SUBSURFACE INVESTIGATION

SOUTHEAST TRANSITWAY - CN BEACHBURG

CNR GRADE SEPARATION

REPORT NO. SF-3062  
August 29, 1990

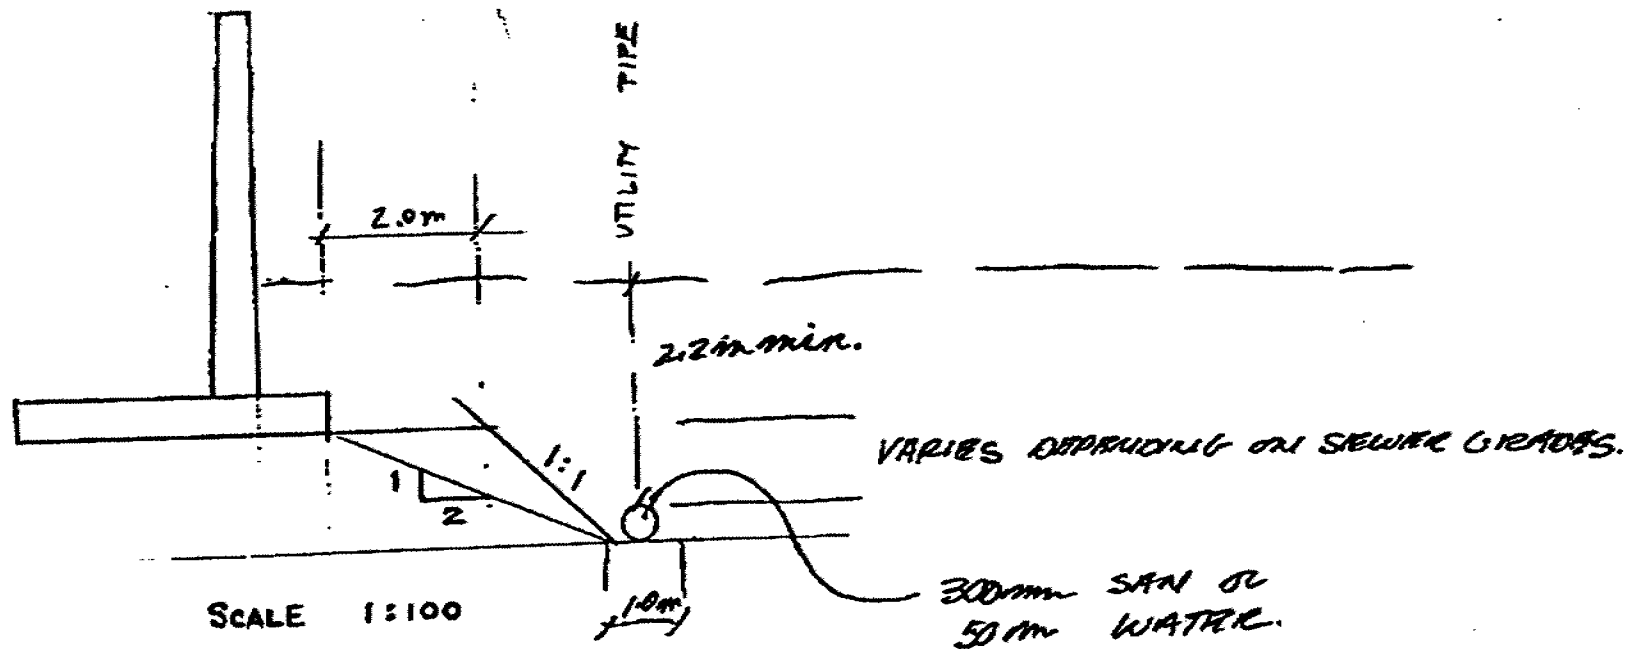
The lateral stability of the retaining walls at the location of proposed utility pipes needs to be assured. The edge of trench needs to be at a minimum

distance such that it falls beyond an imaginary line drawn at two (2) horizontal to one (1) vertical units from the underside of footing as shown on the accompanying plate.

PLATE N° 52

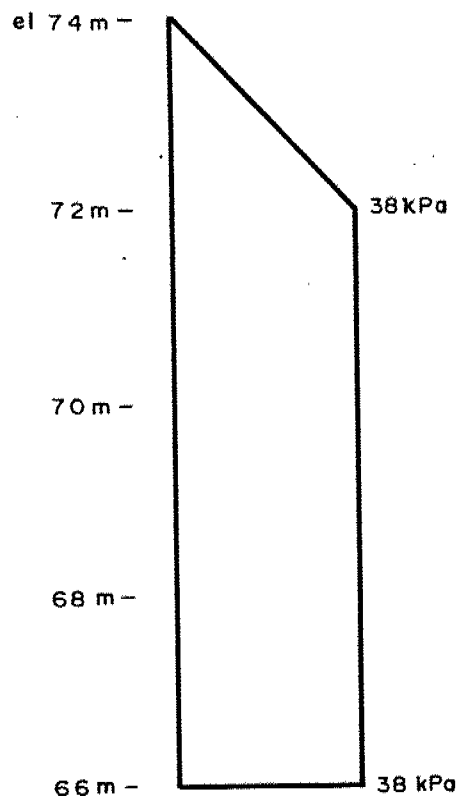
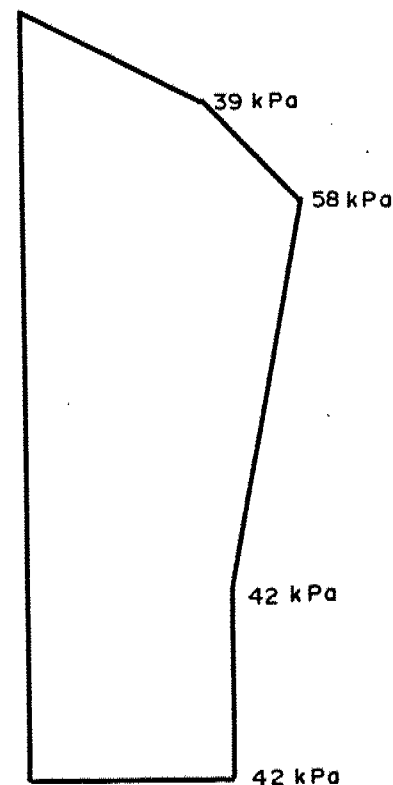
The earth pressure diagram on Plate No. 52 of our report SF-3062 is purposely conservative because of the restriction of limiting the settlements of the existing railroad to negligible amounts.

In order to increase the deadman anchor capacity by a significant amount, we suggest that they be deepened by about one (1) metre. At this depth they should be set back at least fifteen (15) metres behind the face of the wall.

There will be a few anchors in compacted Granular 'B' backfill and these can be expected to provide at least as much resistance as those placed in clay soils. We still recommend that a reduction factor of at least 2.0 be applied to passive earth pressures.

- soil density 16.5 kN/m<sup>3</sup>
- passive earth pressure coefficient 3.40

EFFECT OF WATERMAIN TRENCH

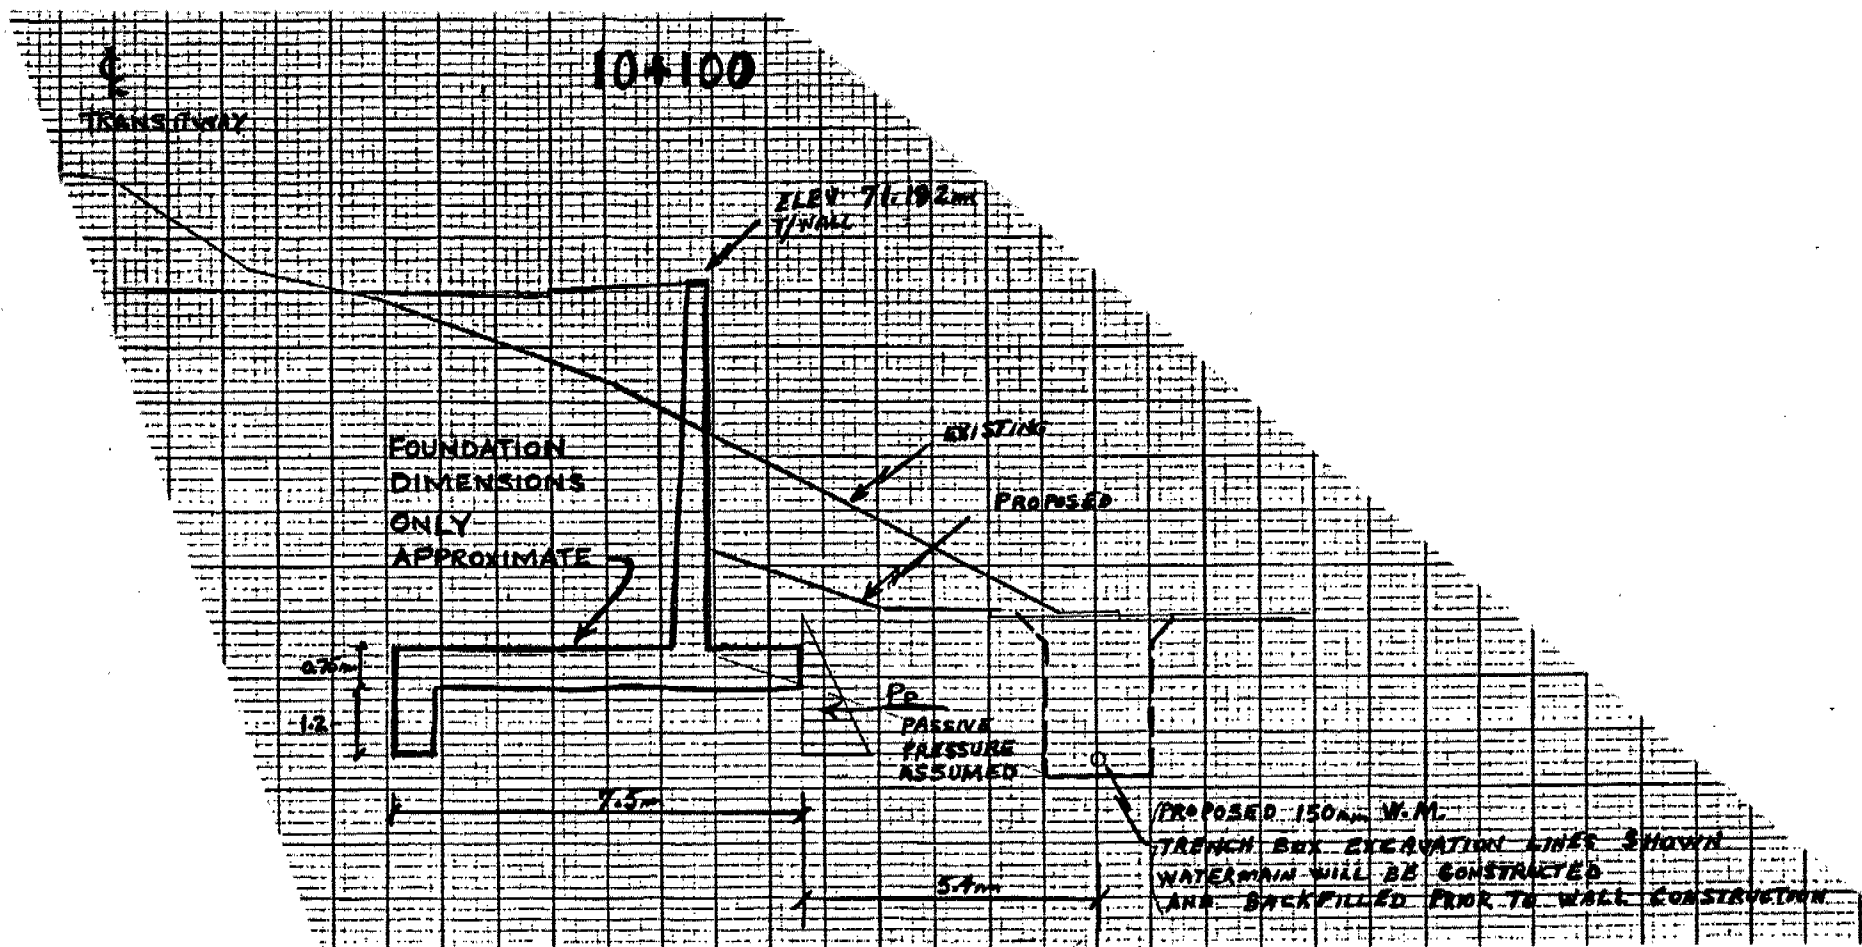
The lateral stability of the retaining walls at the location of proposed utility pipes needs to be assured. The edge of trench needs to be at a minimum distance so that it falls beyond an imaginary line drawn at two (2) horizontal to one (1) vertical from the underside of footing. The trench backfill needs to be compacted however in order to provide lateral resistance.
